Re: Low Level Road Project

HOW TO FIT A PROPER CYCLE PATH ON THE LOW LEVEL ROAD

Option 1: Bike path and sidewalk (4.5 metres + .5 metre shy distance)

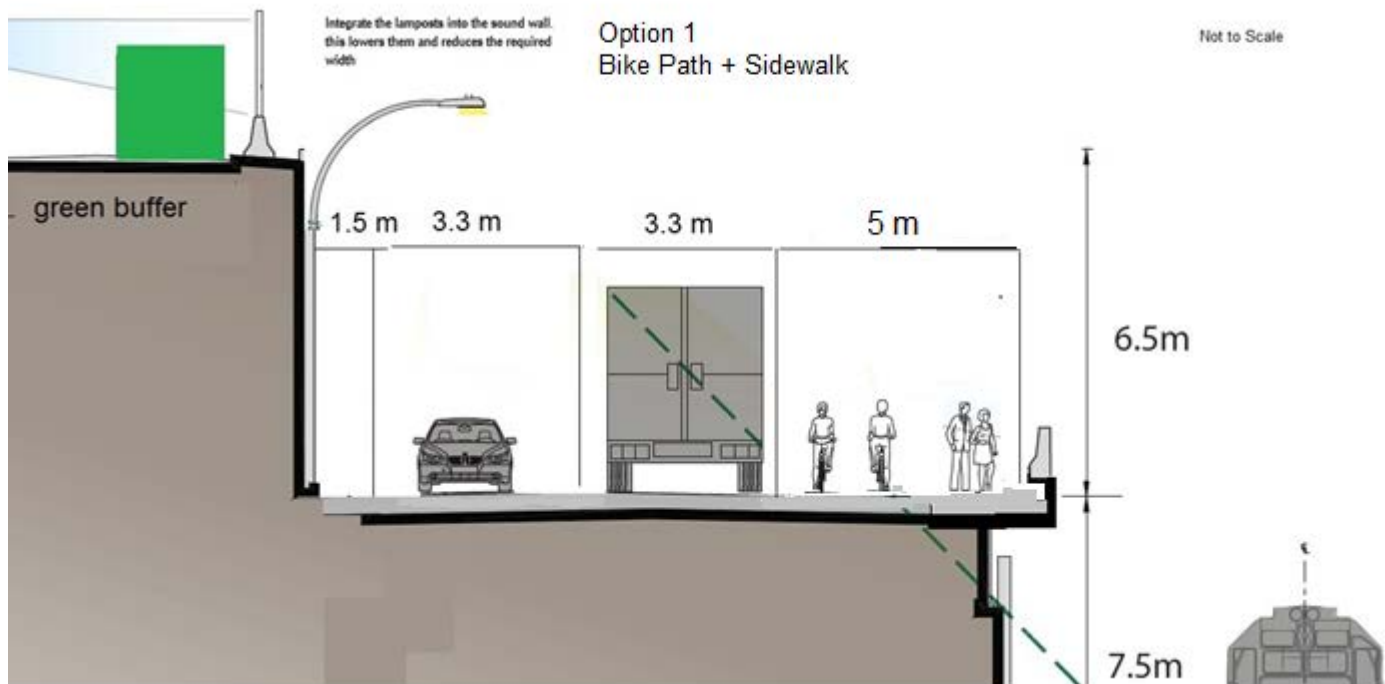
Option 1 separates vehicles from bikes and bikes from pedestrians and other sidewalk users. To obtain more space, we recommend a cantilever where feasible. Note that even with this cantilever design, we are asking only for an increase on the South side NOT 2.6 metres on both sides as stated in the response. If the roadbed is currently 11 metre we are asking for a total increase of 2.1 metres, assuming the north side shoulder width is reduced to 1.5 metres. If the other suggested design adjustments are made, the working surface would be closer to 12 m in which case require only 1 additional metre.

Option 2: Multi-use path (4 metres + 0.5 metres shy distance)

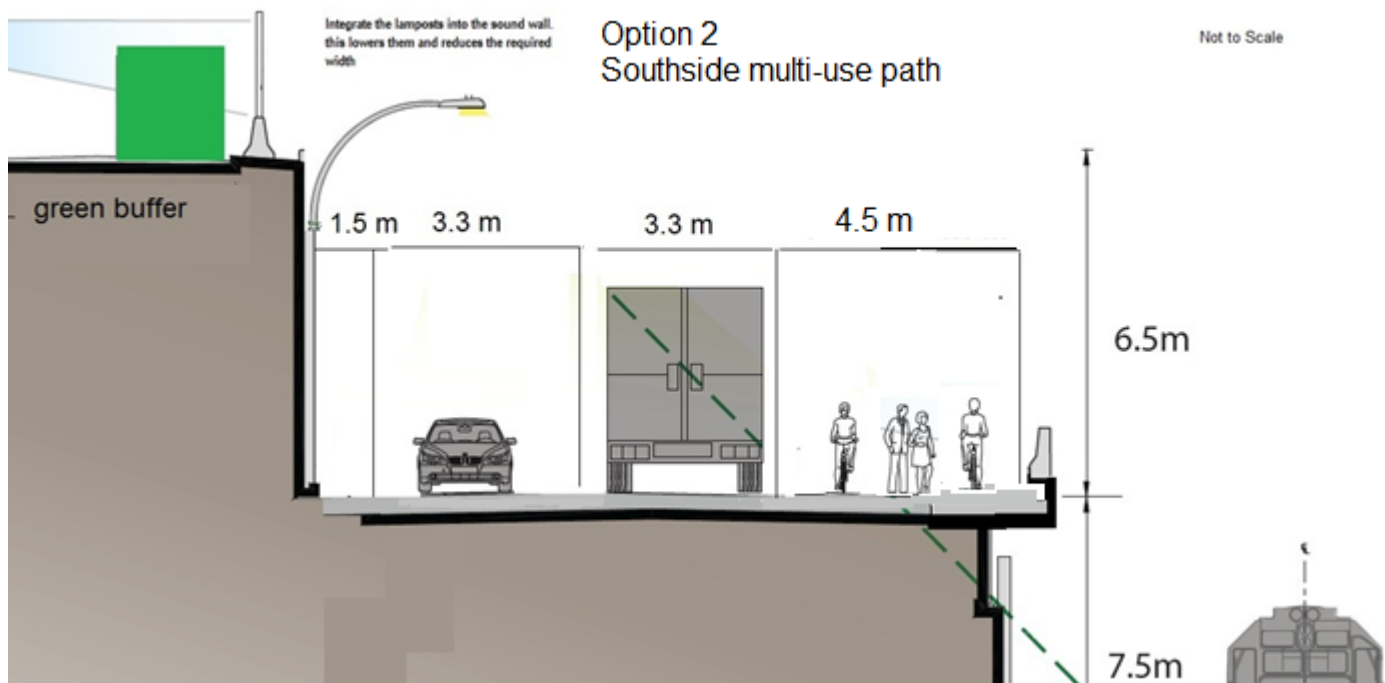
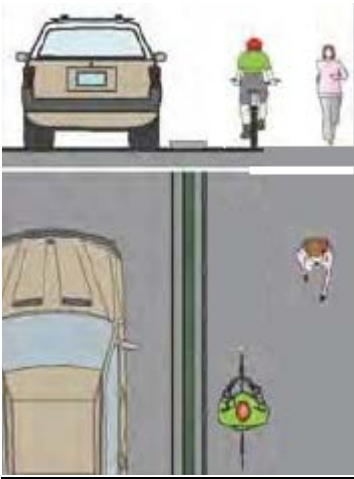
To accommodate both cyclists and pedestrians, we recommend a cantilever where feasible to provide a separated multi-use path. This type of path would also provide a good route for people in wheelchairs and personal mobility devices as well as other active forms of transportation including skate boards and in-line skates. Note that even with this cantilever design, we are asking only for an increase on the South side NOT 2.6 meters on both sides as stated in the response. If the roadbed is currently 11 m we are asking for a total increase of about 1.6 metres on ONE side only, assuming the north side shoulder width is reduced to 1.5 metres or other equivalent design adjustments are made. If the other suggested design adjustments are made, the working surface would be closer to 12 m in which case this design requires only .5 additional metres.

Option 3: Bike path only (3 metres + 0.5 metres shy distance)

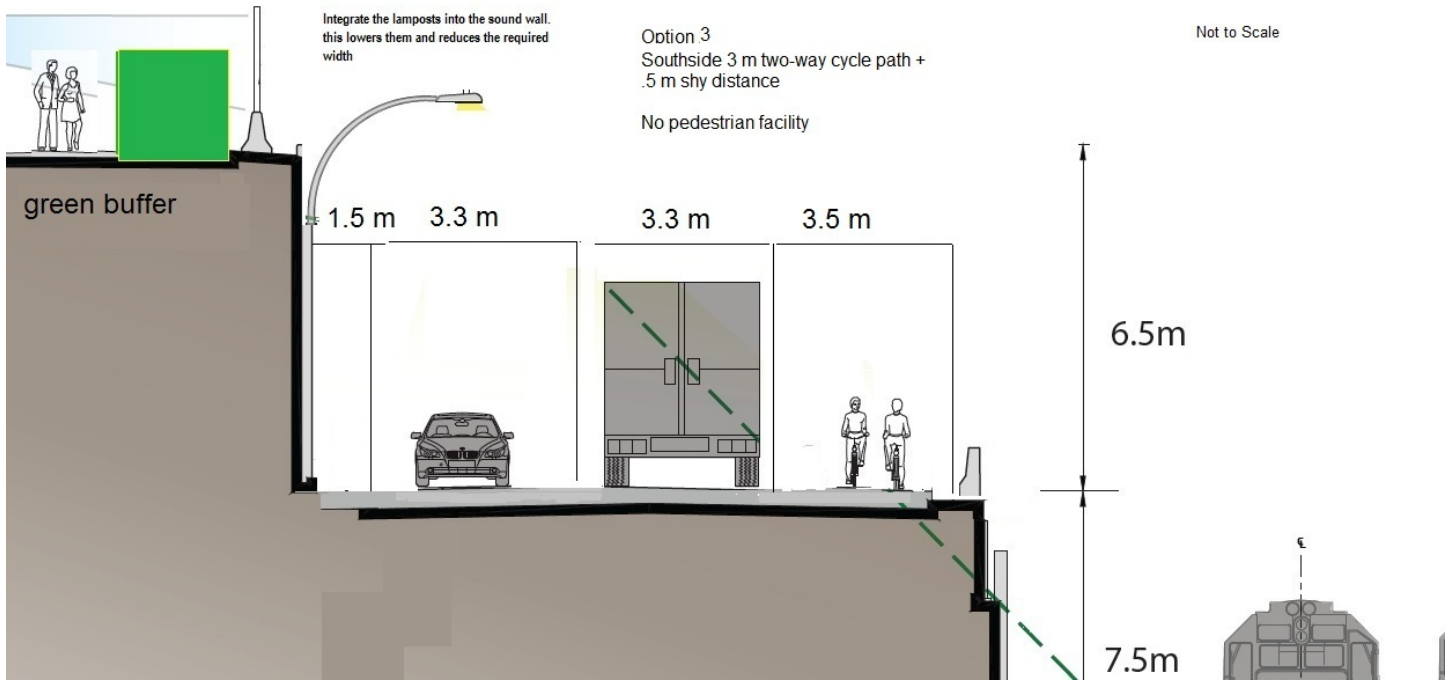
In option 3 we suggest keeping almost the same road bed size and including a two-way south side cycle path with some kind of separation. This design would require less width than either Option 1 or Option 2, however it assumes pedestrians will not have a dedicated space. If the roadbed is currently 11 m we are asking for a total increase of ~ 0.6 metres on ONE side only, assuming the north side shoulder width is reduced to 1.5 metres or other equivalent design adjustments are made. If the other suggested design adjustments are made, the working surface would be closer to 12 m in which case NO additional space is required.
